Project Name: Persigo Village – Final

REVIEW / SHEET SUMMARY

FILE NO. 63-81 3/3 TITLE HEADING Persigo Village Phase I Final Plat DUE DATE 10/14/82
ACTIVITY - PETITIONER - LOCATION - PHASE - ACRES Petitioner: M. Ray Painter/ PWS Investments.
Location: Southeast corner of G Road and 25 Road. A request for a final plat and plan of
84 units on approximately 5.7 acres in a planned residential zone at 17 units per acre.
a. Consideration of final plat. b. Consideration of final plan.

The following is submitted in response to comments for the project review of the Persigo Village Preliminary Plan and Final Plat for Phase I.

PERSIGO VILLAGE
UTILITY COMPOSITE
 Turner Collic & Braden Inc.
 1700 W. 10th St., Suite 100, Grand Rapids, MI 49503
 Phone: (616) 941-1111
 Fax: (616) 941-1112

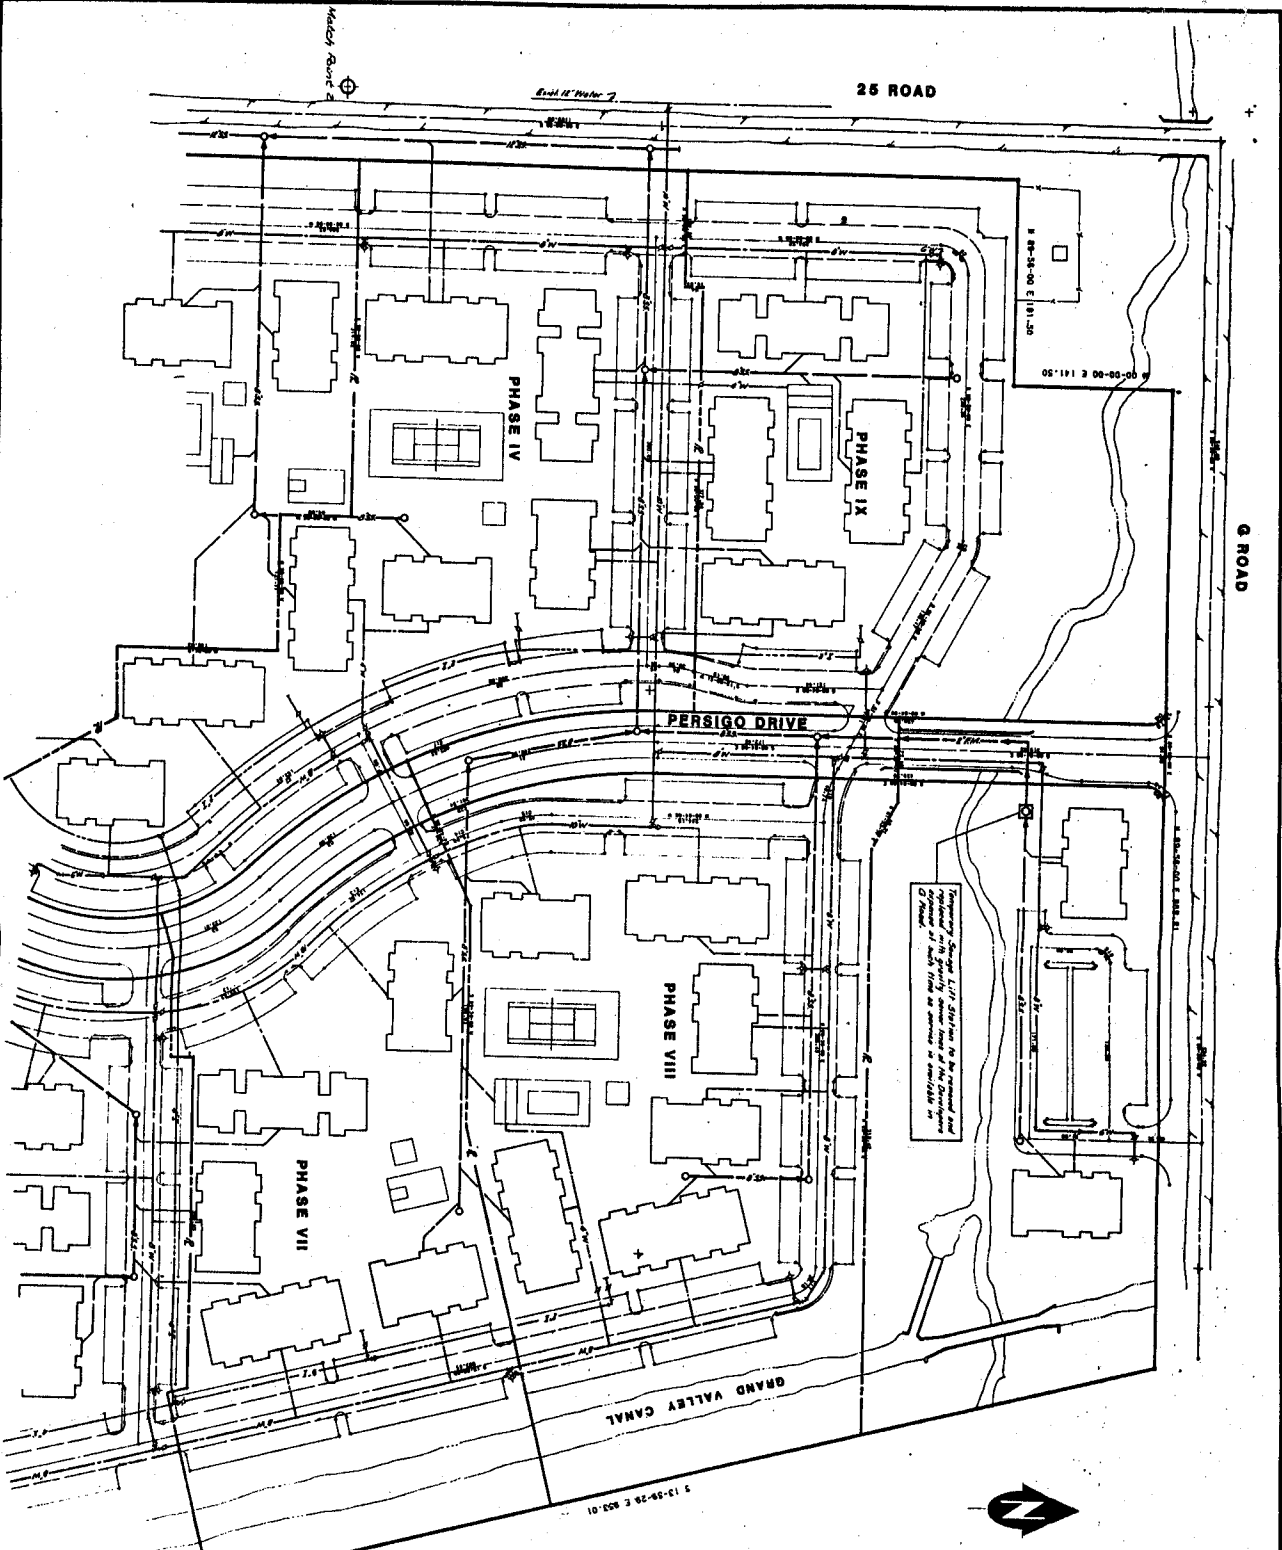
6/10/83	City Utilities	<p>Manholes should be constructed at the end of all sanitary sewer lines. The plugged ends shown on the plans are not adequate for cleaning and maintenance. The 6" sewer line extending north of MH B-2 should be changed to 8" pipe. This line is too close to the building (10' min.) and also needs a manhole at the end of the line. This sewer line is in a B.E. (building Envelope) area. If utility easements are not included in B.E., then a separate 20' utility easement should be provided for the sewer line.</p>
6/10/83	City Eng.	<p>This review does not constitute approval of construction plans for the sanitary sewer system. Construction plans for the sewer system must be approved prior to construction.</p>

4. Utility Composite
 - Realigned waterlines in accordance with wishes of Ute Water
 - Added trash pick-up locations
 - Reworded Note 2 as directed by Ute Water
